ADDENDUM #2
ORANGE BRANCH PARKING LOT
DELAWARE COUNTY DISTRICT LIBRARY

Friday, September 10, 2021

ORANGE BRANCH PARKING LOT
DELEWARE COUNTY LIBRARY

BIDDING		
DATE: _____		
REVISIONS		
Δ	DATE	DESCRIPTION
1	8/10/2021	ADDENDUM #1
2	9/10/2021	ADDENDUM #2
####	####	####
####	####	####
####	####	####
####	####	####
PROJECT NO.:		21-00326-010
DRAWN BY:		CMR
CHECKED BY:		JSO
DATE ISSUED:		08/30/2021
PARKING LOT PLAN		
1	OF	2

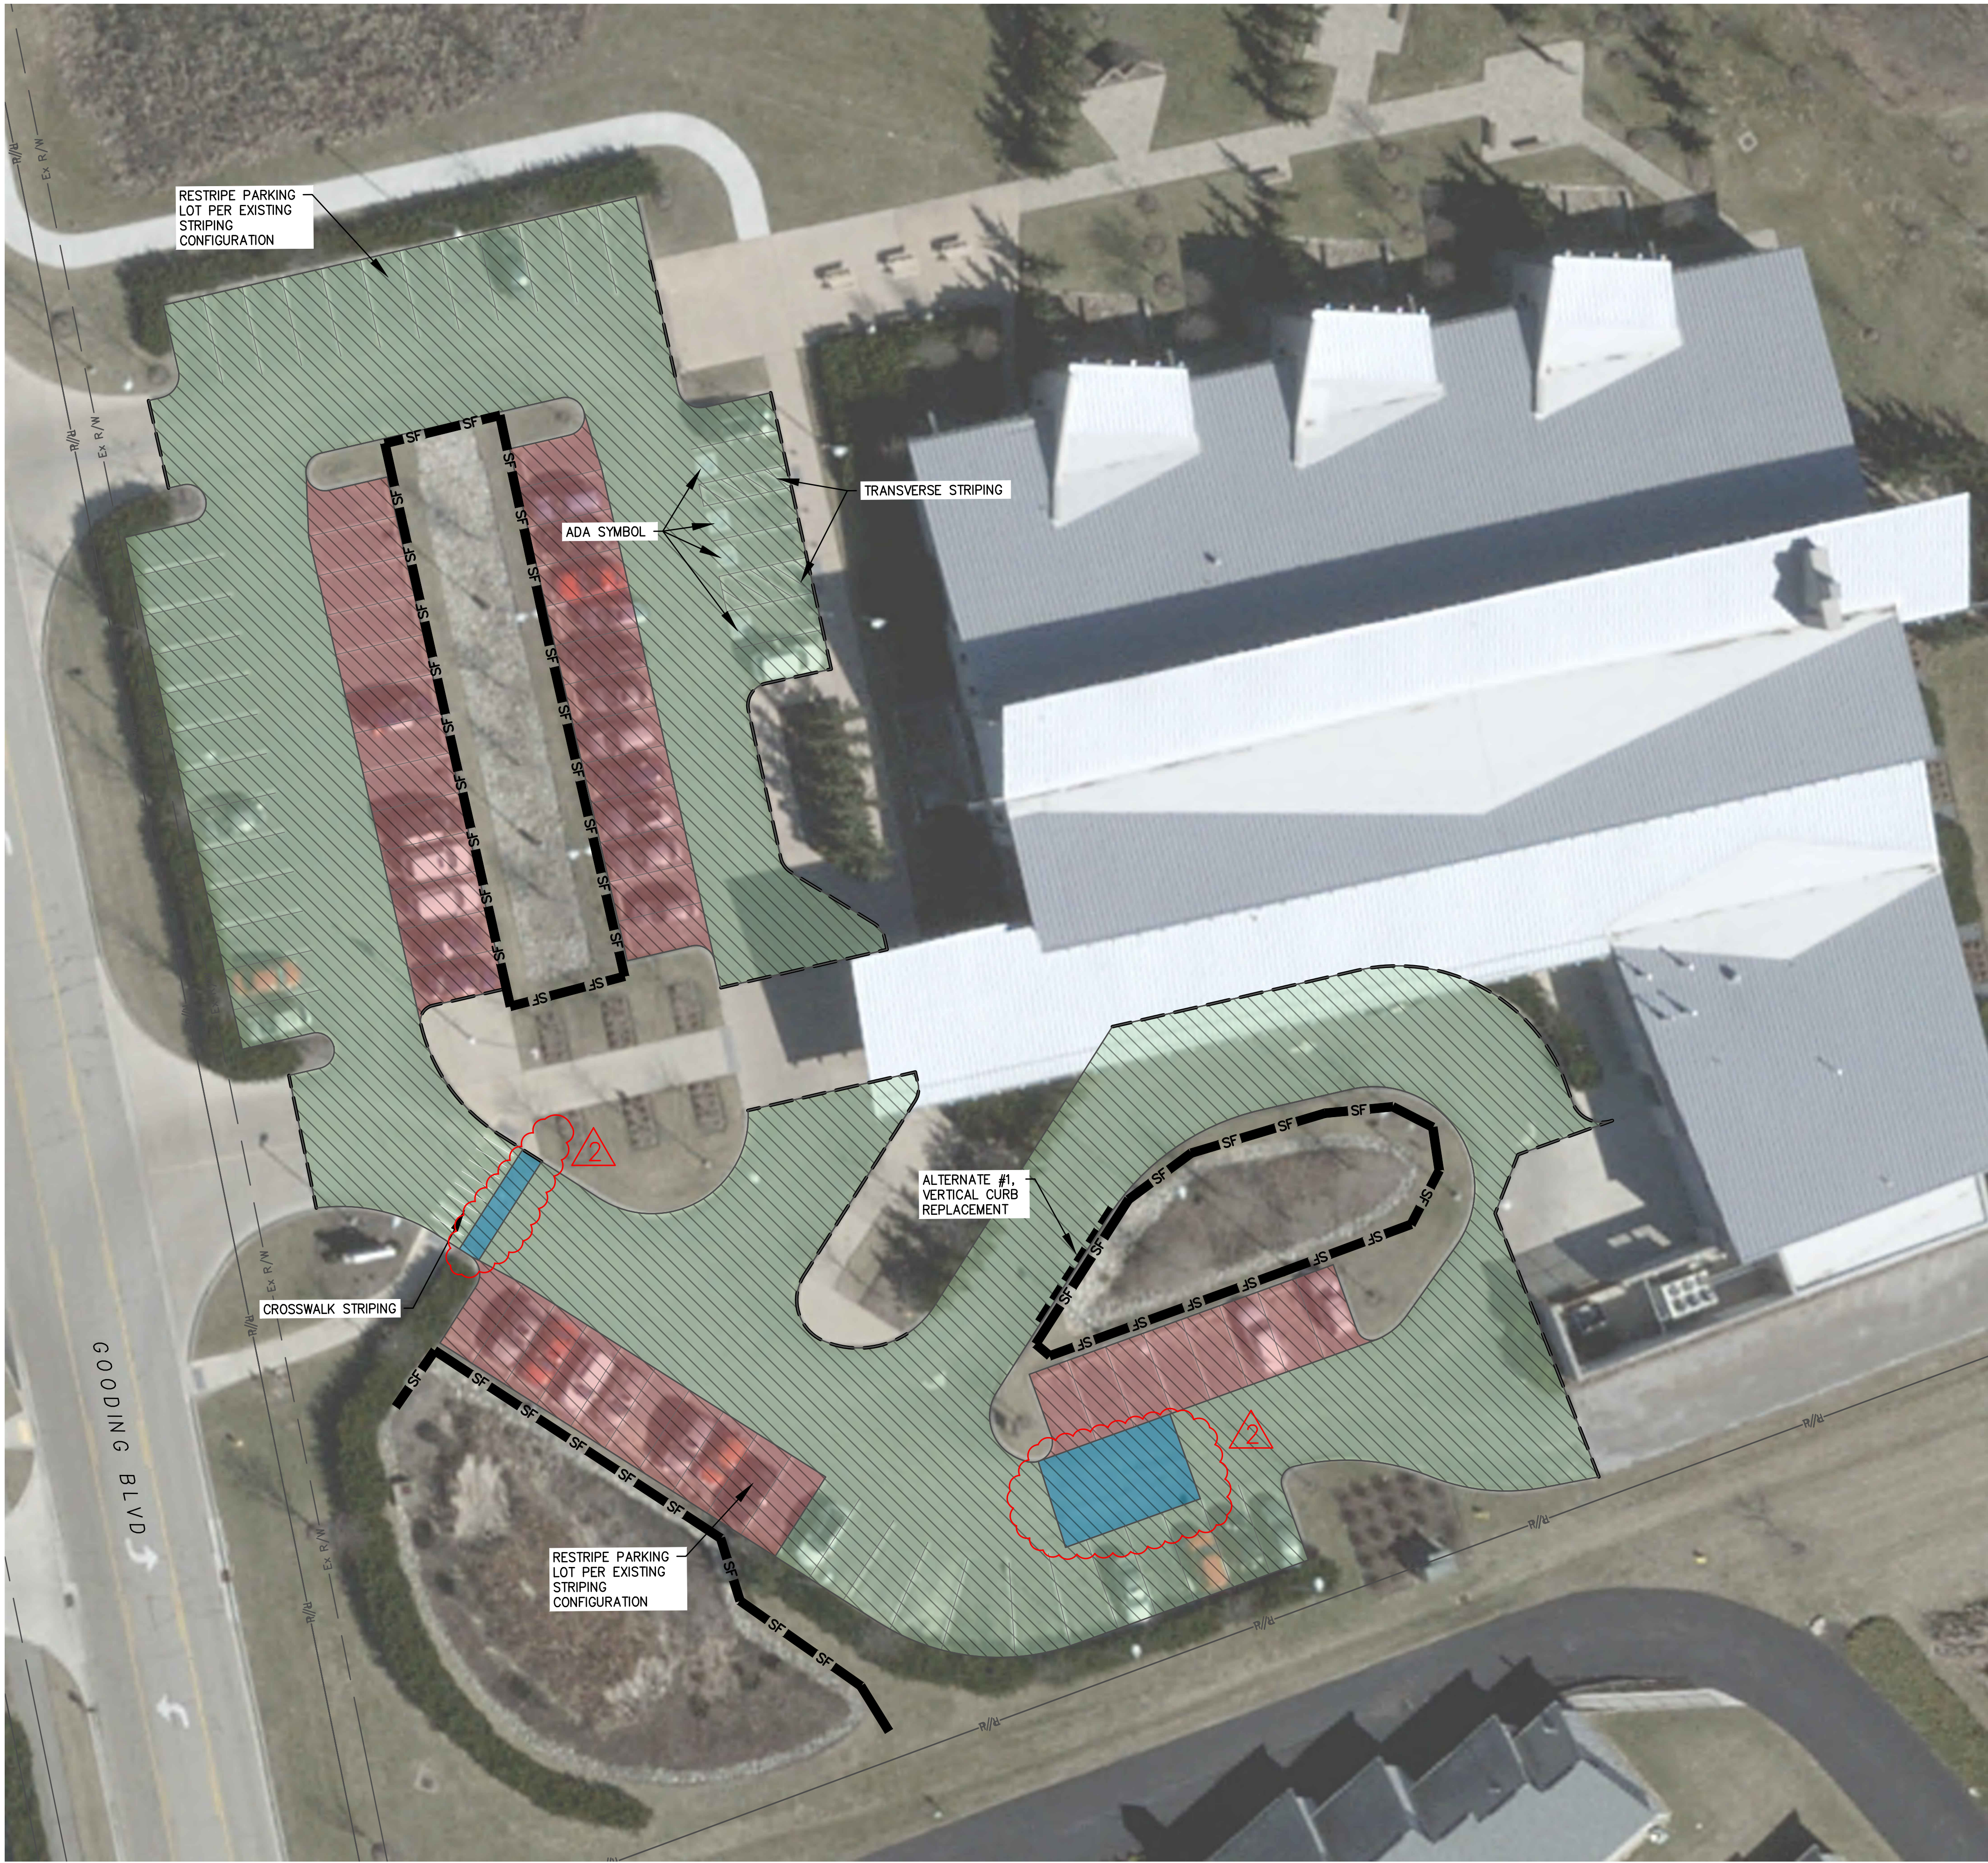
- A. Sheet 1:
 - 1. **Additional full-depth pavement areas have been added. These areas will be heavy-duty pavement areas per Detail 1 on Sheet 2.**
 - 2. **The quantity of asphalt planing and overlay has been modified to account for the additional full-depth removal.**
 - 3. **A note has been added directing the Contractor to replace damaged concrete wheel stops as necessary. A detail for new concrete wheel stops has been added to Sheet 2.**
- B. Sheet 2:
 - 1. **Detail 2 has been updated to note ODOT 702.17, Type 2 crack sealant.**
 - 2. **Detail 3 for partial depth removal has been removed from the project.**
 - 3. **Detail 7 has been added for concrete parking blocks.**

2 FULL DEPTH REPAIR
2 NOT TO SCALE

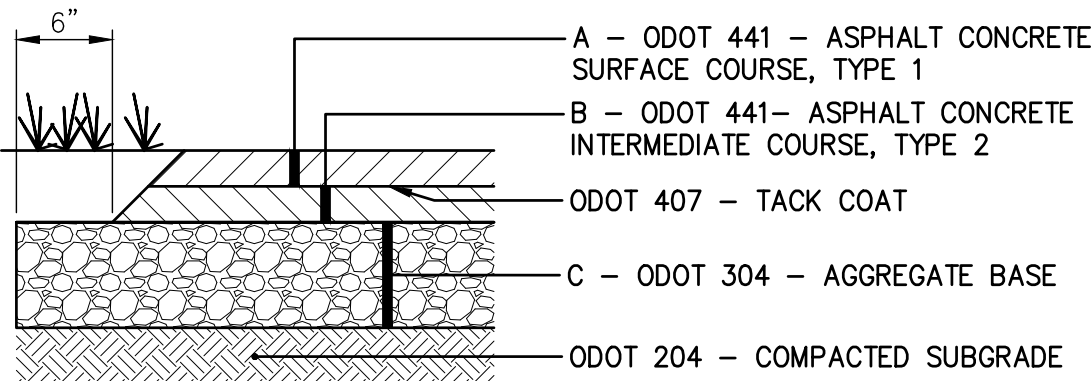
- E. Will crack sealing per ODOT Item 423 be Type 2?

Yes, Crack Sealing per ODOT 423 should be Type 2. Detail 2 on Sheet 2 has been updated to indicate this specification.
